**Decision Notice – change application – minor change  
(Given under section 83 of the *Planning Act 2016*)  
Material Change of Use & Reconfiguring a Lot  
Lots 1 & 4 on RP850853, 2 & 8 Mill Street, Goondiwindi**

**Decision for change application**

Application number: 22/32  
Approval sought: Minor Change to Existing Development Permit  
Details of proposed development: Material Change of Use - "Business Activities" – "Food and Drink Outlet" (Drive Through Restaurant) and Reconfiguring a Lot (Boundary Realignment) and Easement Giving Access to a Constructed Road

Drawing Title  
PROP. SITE PLAN

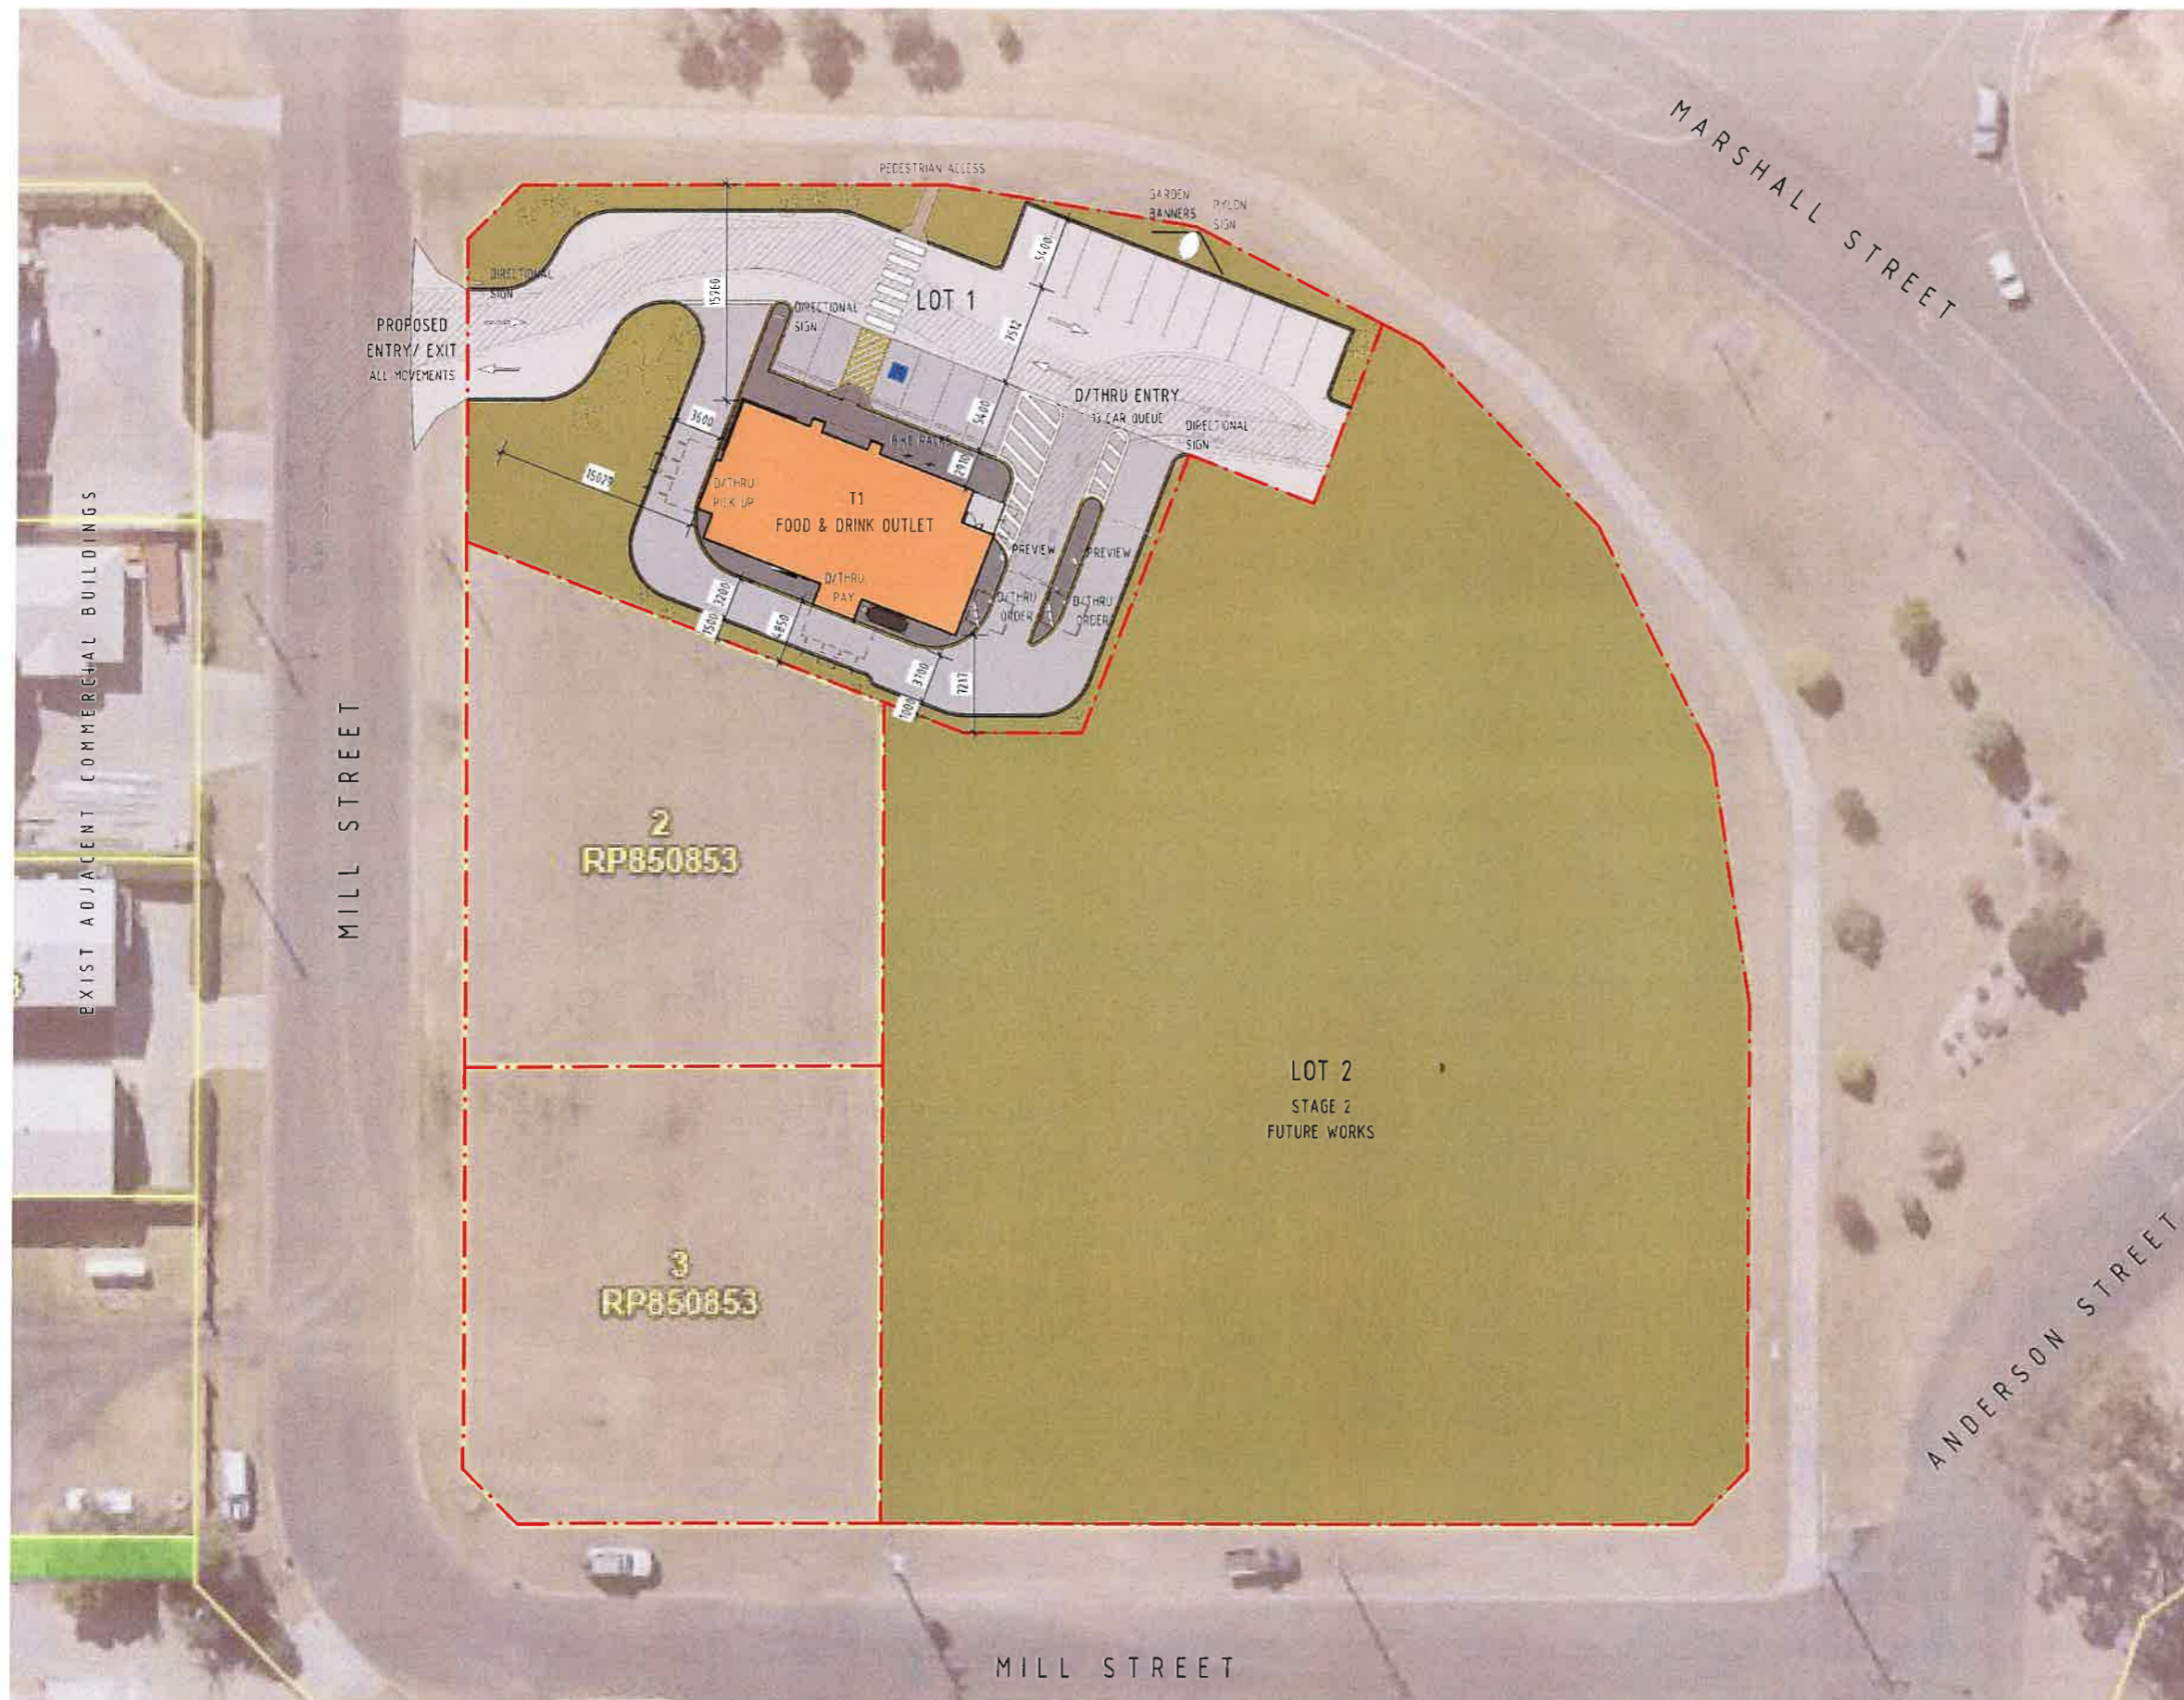
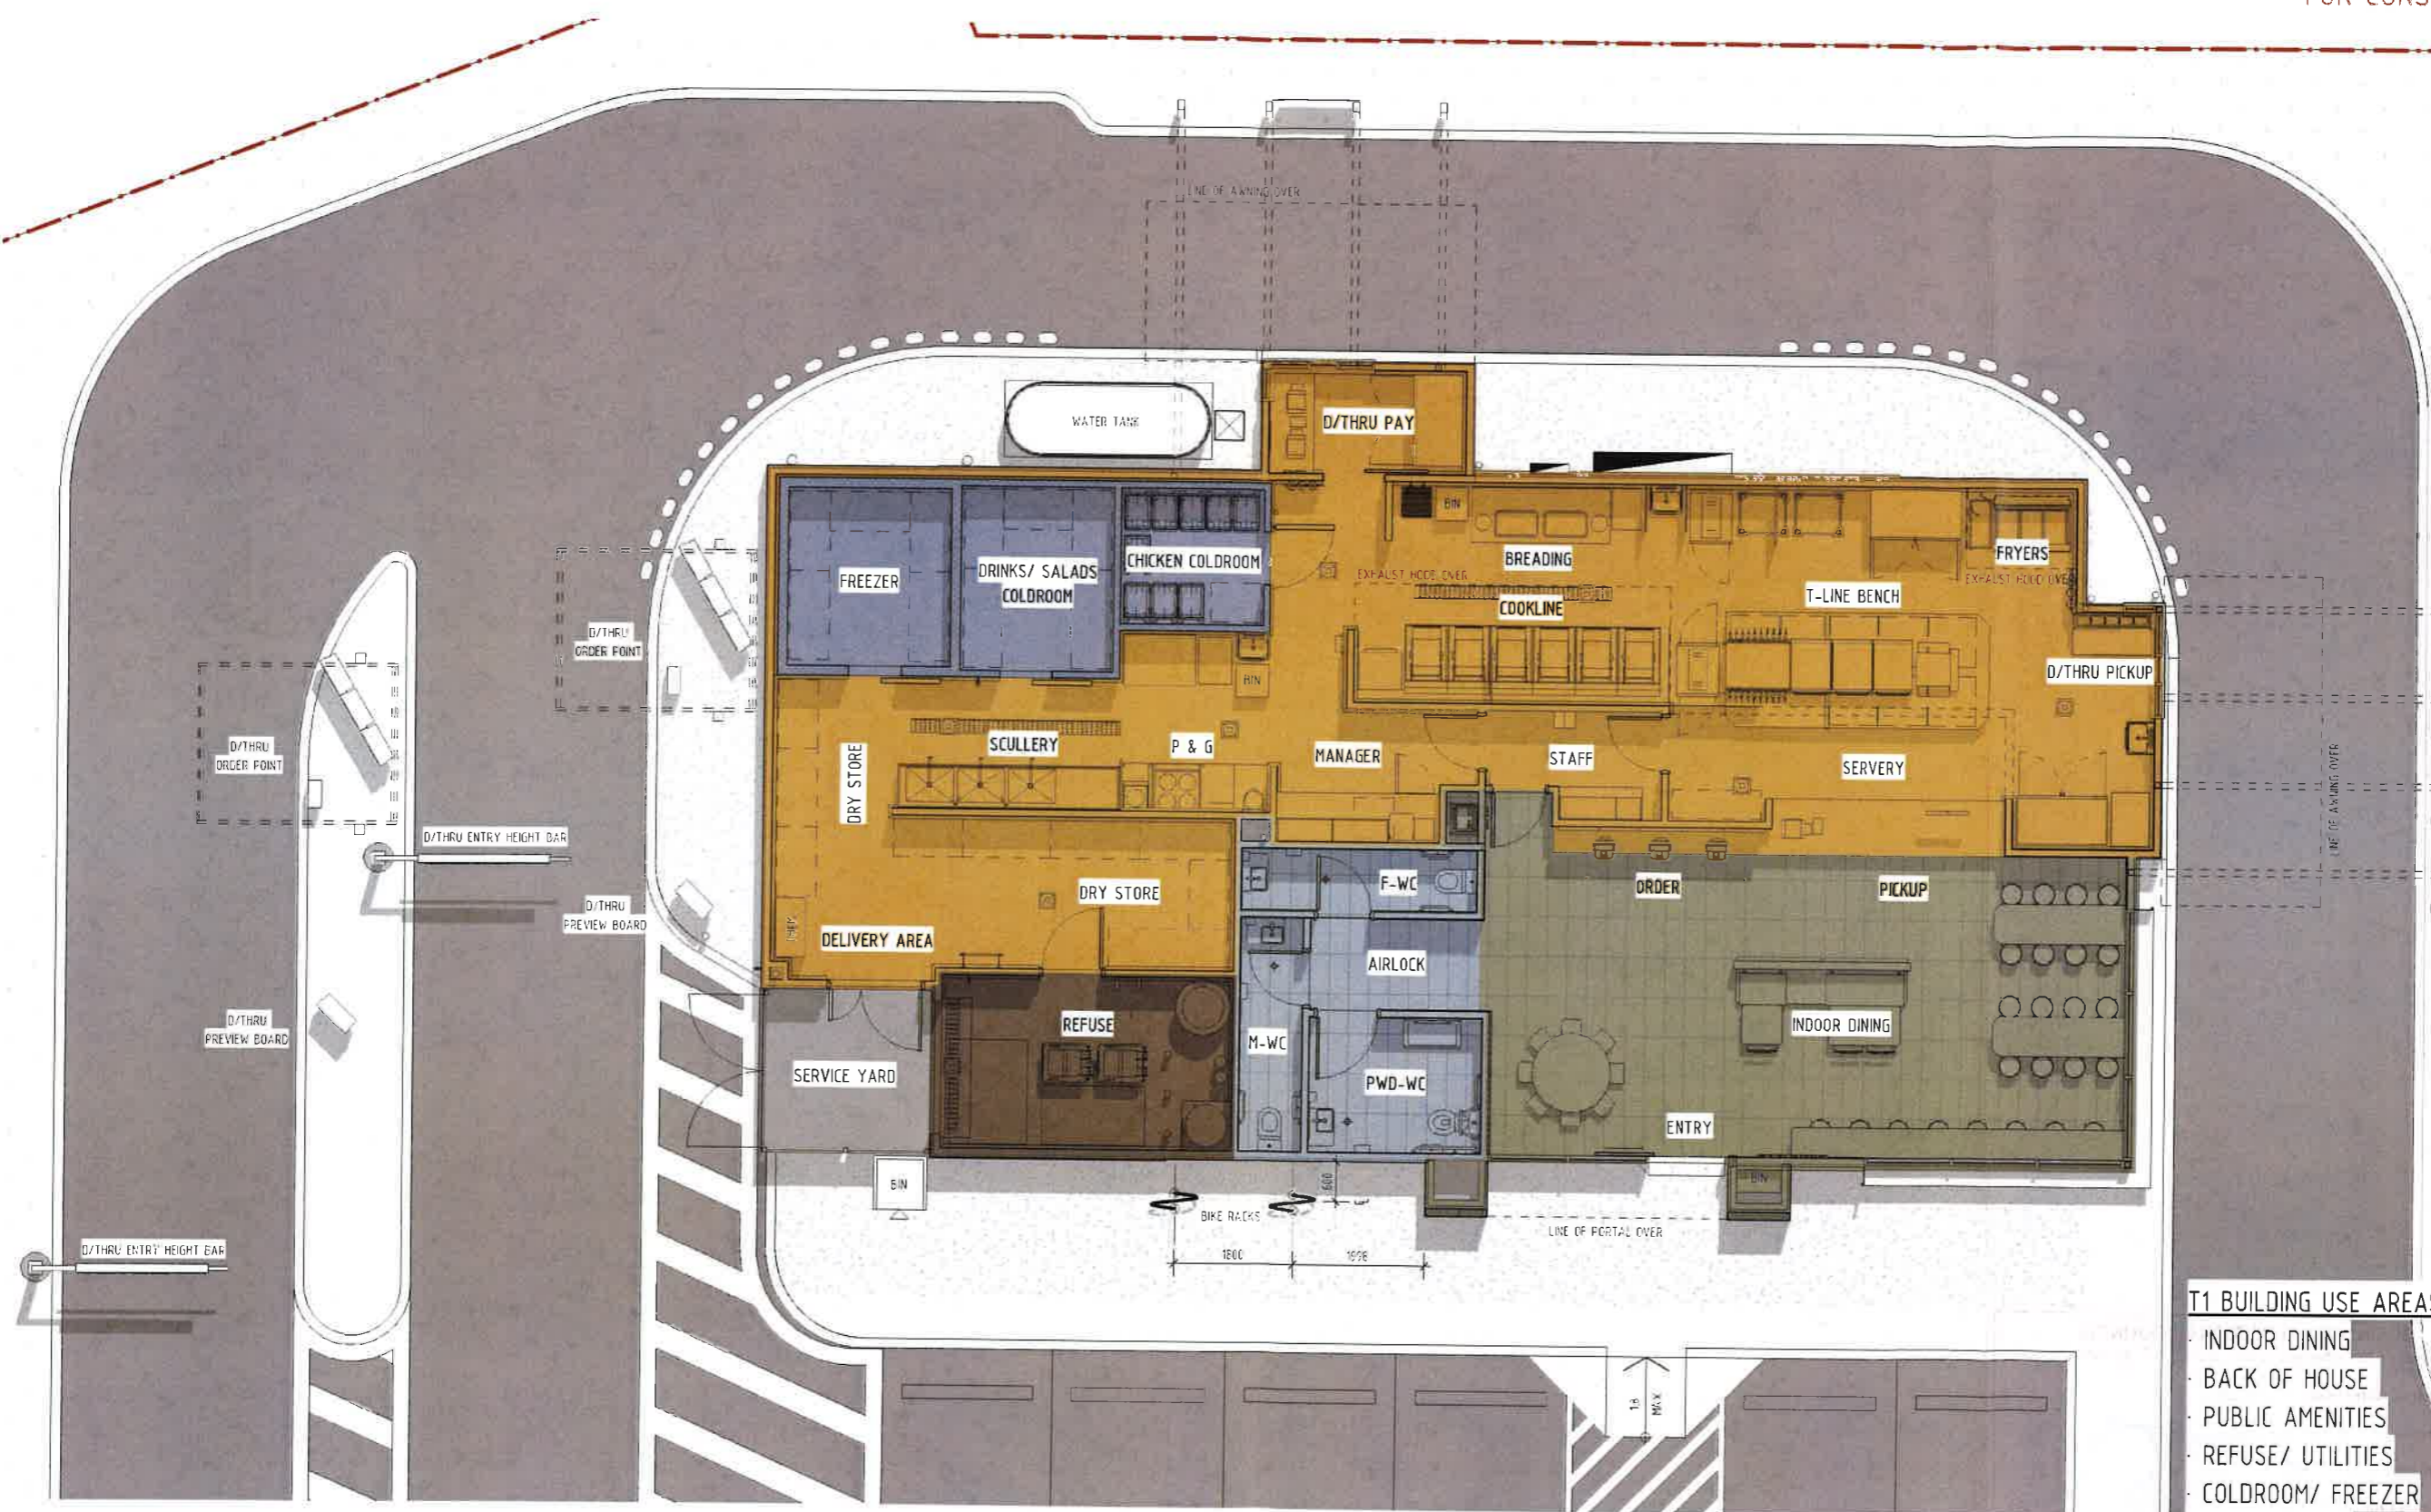
Drawing Number	Title	Date
DA01, Rev. B	Prop. Site Plan	03.08.2022
DA02, Rev. A	Prop. Floor Plan	03.08.2022
DA03, Rev. A	Building Elevations & Perspectives	03.08.2022
DA04, Rev. A	Building Elevations & Perspectives	03.08.2022
DA05, Rev. B	Site Perspectives	03.08.2022
DA08, Rev. B	Subdivision Plan	03.08.2022
2205200 SD-02	Schematic Design – Landscape Plan	11-08-2022
2205200 SD-03	Indicative Planting Palette & Landscape Sections	11-08-2022
22100 Report	Environmental Noise Impact Report	12.08.2022
BE220369-RP-TIA-01	Traffic Impact Assessment	12.08.2022
BE220369-RP-CSMP-00	Conceptual Stormwater Management Plan	11.08.2022

Drawing Number	Title	Date
DA01, Rev. E	Prop. Site Plan	06.07.2023
DA02, Rev. A	Prop. Floor Plan	03.08.2022
DA03, Rev. A	Building Elevations & Perspectives	03.08.2022
DA04, Rev. A	Building Elevations & Perspectives	03.08.2022
DA05, Rev. B	Site Perspectives	03.08.2022
DA08, Rev. C	Subdivision Plan	21.07.2023
2205200 LP-01	Schematic Design – Landscape Plan	26.07.2023
2205200 CS-01	Indicative Planting Palette & Landscape Sections	26.07.2023
22100 Report	Environmental Noise Impact Report	12.08.2022
BE220369-RP-TIA-01	Traffic Impact Assessment	12.08.2022
BE220369-RP-CSMP-00	Conceptual Stormwater Management Plan	11.08.2022

Drawing Number	Title	Date
<b>DA01, Rev. E</b>	<b>Prop. Site Plan</b>	<b>06.07.2023</b>
DA02, Rev. A	Prop. Floor Plan	03.08.2022
DA03, Rev. A	Building Elevations & Perspectives	03.08.2022
DA04, Rev. A	Building Elevations & Perspectives	03.08.2022
DA05, Rev. B	Site Perspectives	03.08.2022
<b>DA08, Rev. C</b>	<b>Subdivision Plan</b>	<b>21.07.2023</b>
<b>2205200 LP-01</b>	<b>Schematic Design – Landscape Plan</b>	<b>26.07.2023</b>
<b>2205200 CS-01</b>	<b>Indicative Planting Palette &amp; Landscape Sections</b>	<b>26.07.2023</b>
22100 Report	Environmental Noise Impact Report	12.08.2022
BE220369-RP-TIA-01	Traffic Impact Assessment	12.08.2022
BE220369-RP-CSMP-00	Conceptual Stormwater Management Plan	11.08.2022
